Re: Crowell Road Intersection Project #607405

These comments are in addition to my earlier comments of October 20, 2017 regarding the proposed project to modify the existing five-leg intersection of Main Street (Route 28) with Crowell Road, Queen Anne Road, and Depot Street.

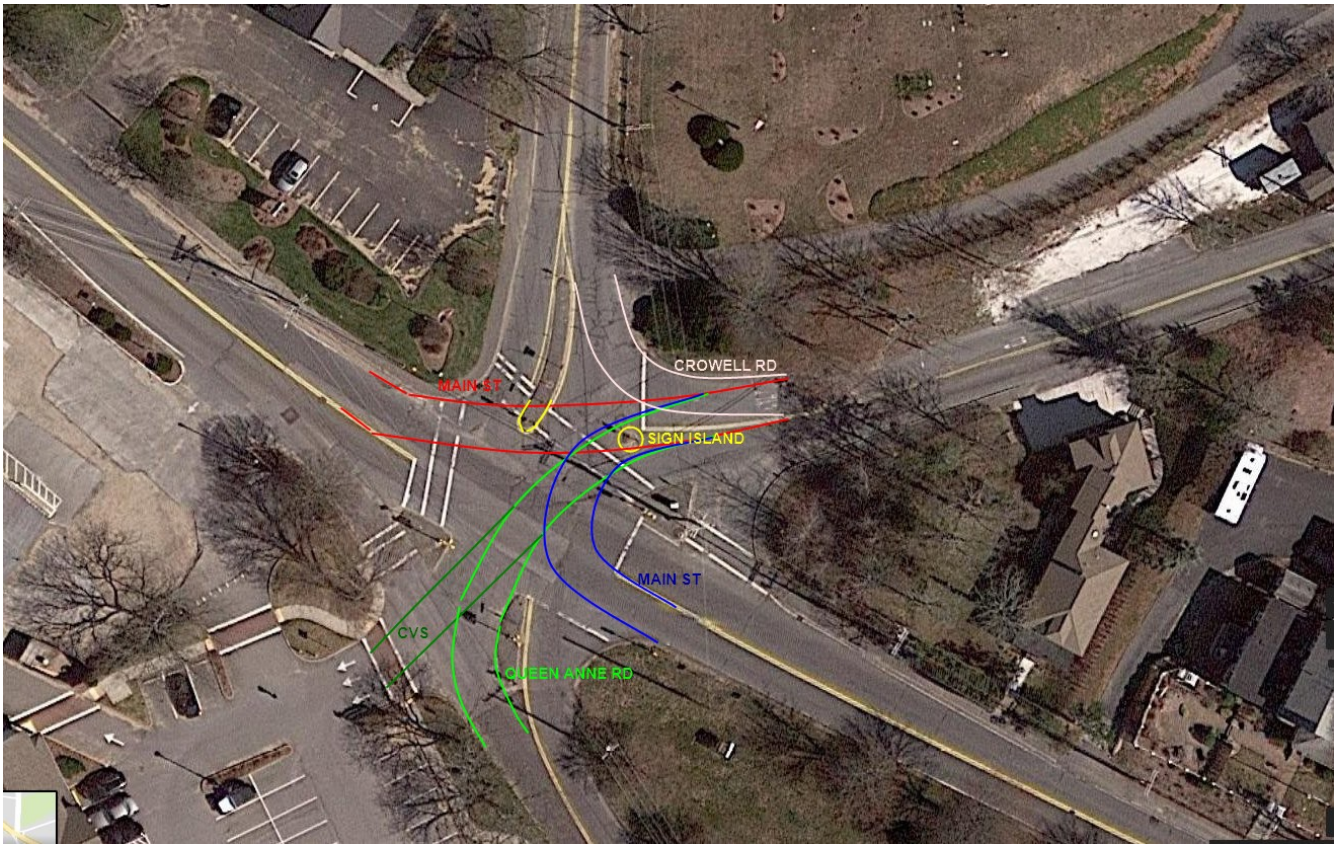
The end of the existing Crowell Rd splitter island and the tiny triangle holding the signage on Depot are certainly in the direct pathway of fire/emergency vehicles as shown here in my annotated JPGs from street and aerial views. This requires FD to lane-jump into opposing traffic lane on Depot to go anywhere except Crowell.

Should this lower section of eastbound Depot be blocked by a vehicle, which admittedly may be a rare event, the FD would have no path to use! So the existing configuration has a problem but the proposed solution #3 doesn't make it any better, but actually makes it worse by putting a larger island with a mast right smack in the ideal traffic paths that would be used by FD. If we're going to improve this intersection, let's eliminate need to lane-jump, ok?

Here's my annotated JPG showing the problem with #3:

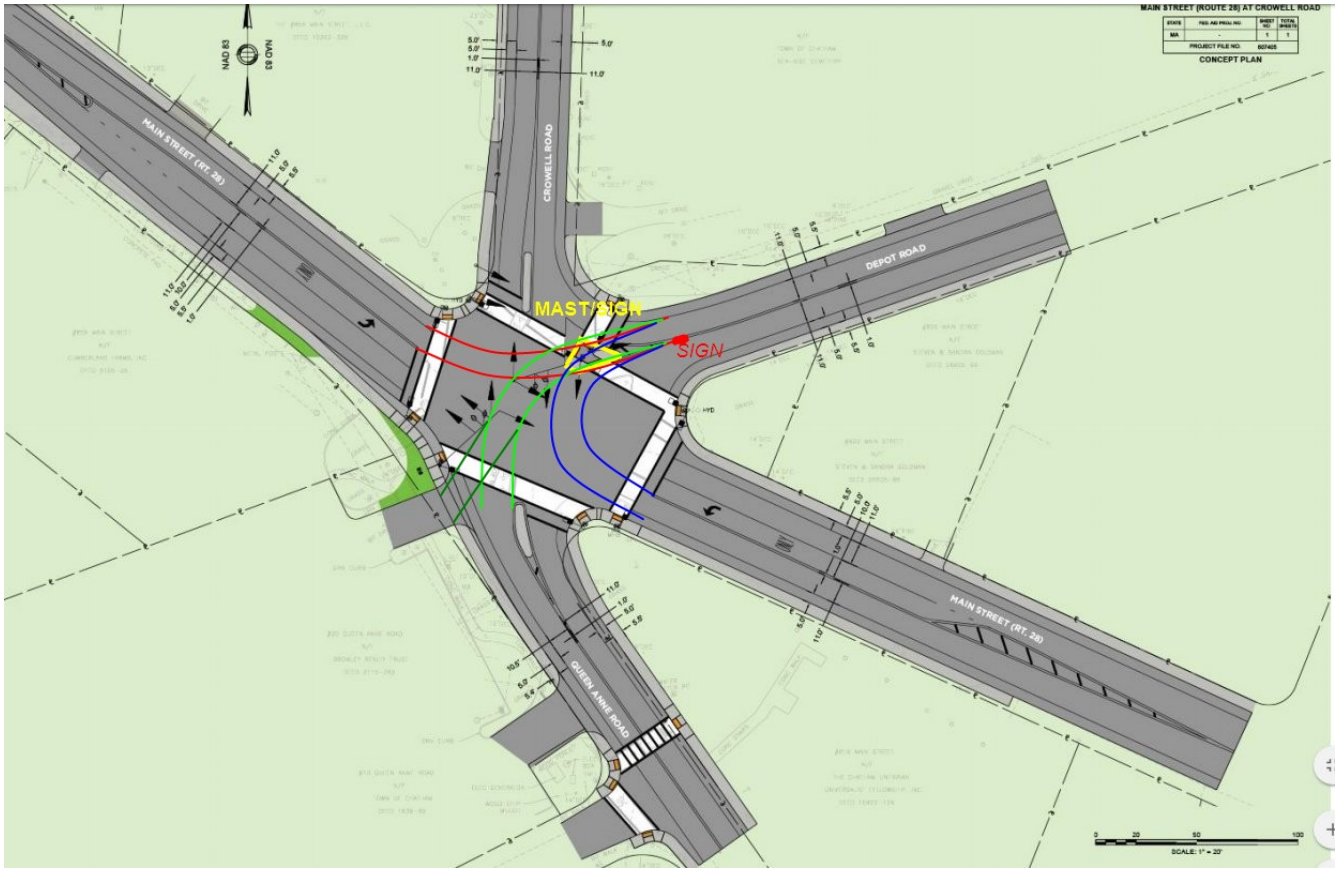
I understand the need to have some sort of an island to divert regular westbound Depot traffic towards Crowell, but anything there (if in ideal pathway) should be mountable by emergency vehicles and/or sized such that a fire truck could span it given their extra width as compared to regular vehicles. Any signals needed should be on masts or posts located on cemetery side or elsewhere, even if that would require an extra one or two mast/posts. Any signage needed on this island must also be out of the way of the most efficient traffic pathway for FD.

The small sign triangle, if needed, could be located a bit 'upstream' where I put "sign" in red so that it's not blocking any traffic path for FD.
